**TELEFAX****AMENDMENTS TO THE DRAWINGS**

09/767,362

FIG. 1

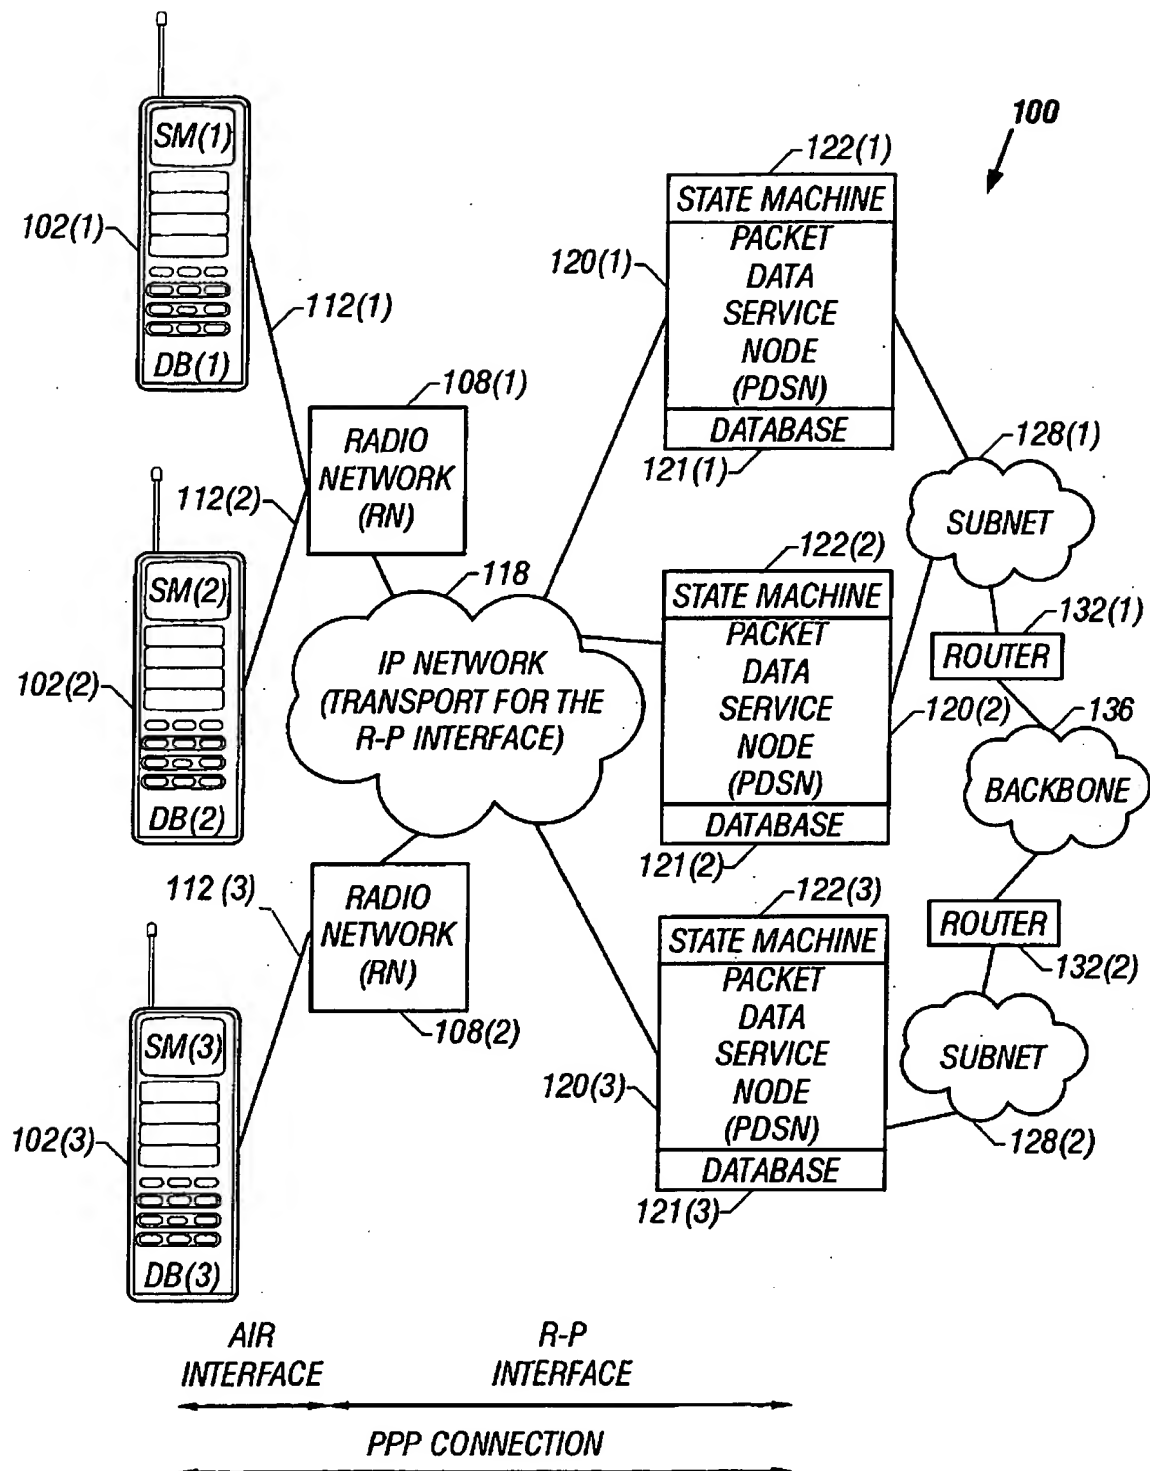
In paragraph 1 of his report, the Examiner objected to the drawings because they fail to show the air interface number 112 (3). For that reason, Applicants submit amended Figure 1, which does not include new material. Amended Figure 1 merely corrects a clerical error. In particular, the interface number 112 (3) and item 112 (3) are described in the Specification, but were missing on original Figure 1. The amended Figure 1 is included herewith on Replacement Sheet.
